PRODUCT UPGRADE BULLETIN: 190312REV

Hydraulic Hose Routing

April 2019

The purpose of this Product Upgrade Bulletin is to inform REV dealers of the need to inspect and, if necessary, correct the routing of hydraulic hoses on certain model year 2016-2019 American Coach brand Class A diesel motorhomes and certain model year 2016, 2018 and 2019 Monaco brand Class A diesel motorhomes.

Figure 2 - Incorrect Routing/Clocking

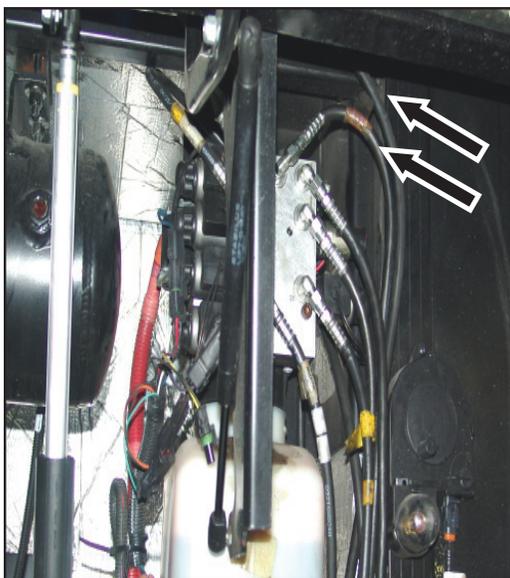
On motorhomes affected by this Product Upgrade, the hydraulic hoses may be connected to the manifold/pump in a manner that causes them to be too tightly coiled, compressed or obstructed, which may cause the hoses to leak.

8. Inspect the routing of each hydraulic hose to identify any that have an overly tight radius and/or are obstructed by any objects, such as adjacent hoses or fittings, chassis components, door strut brackets, etc. Any hoses that are obstructed or have a tight radius may have excess hydraulic fluid pressure. These hoses will need to be repositioned, either by removing and replacing nylon wire ties, or by “re-clocking” the fitting to allow proper routing. See Figures 2-3 for examples of hoses that need to have their routing corrected by repositioning them and/or “re-clocking” their fittings at the manifold/pump. Figures 4-5 are examples of properly routed hoses at the manifold/pump. Review the next 2 pages for further routing details critical to the success of this procedure. See Page 4 for repositioning information and diagrams.

The objective is to minimize the sharp bends or radius of the hoses near the manifold/pump. Depending on the collection point of the hoses as they route forward toward the frame rail, the examples are provided to illustrate the routing possibilities for the motorhome. **(A combination of example A and B may also be considered.)** Once the wire ties are removed a visual inspection is necessary to determine optimum positioning. Once you have inspected the motorhome, use this page to discuss with REV RV Dealer Technical Support to finalize if repairs are needed.

Figure 5 - Correct Routing/Clocking

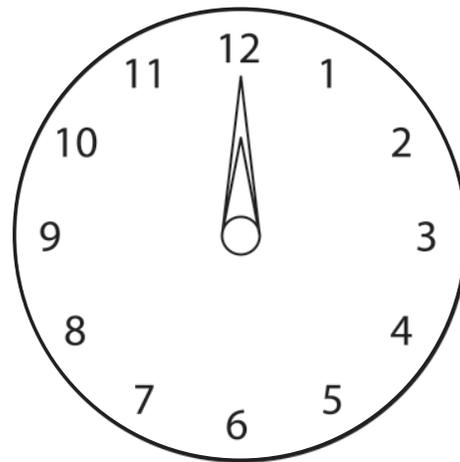
Use this page, "Hose Clocking Reference", and Page 5, "Hose Routing - Reference Only", collectively to improve the hose radius positioning or to determine if any further action is needed.

Figure 6 - Hose Clocking Reference

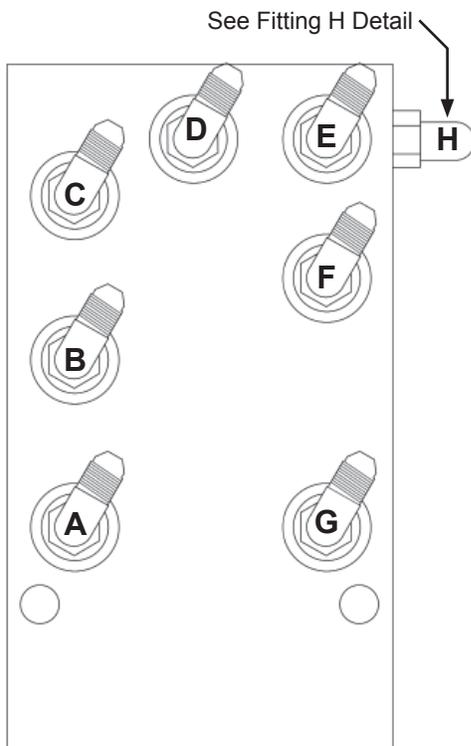
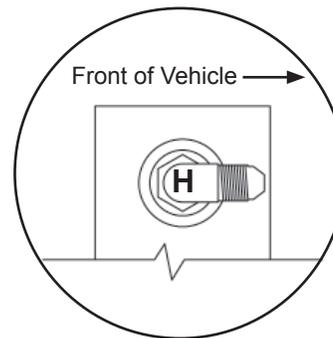
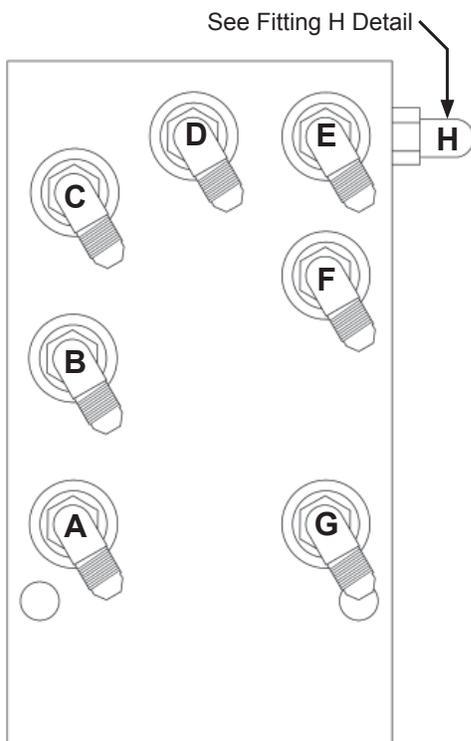
Clock - to be used as reference when receiving instruction from REV Dealer Technical Support
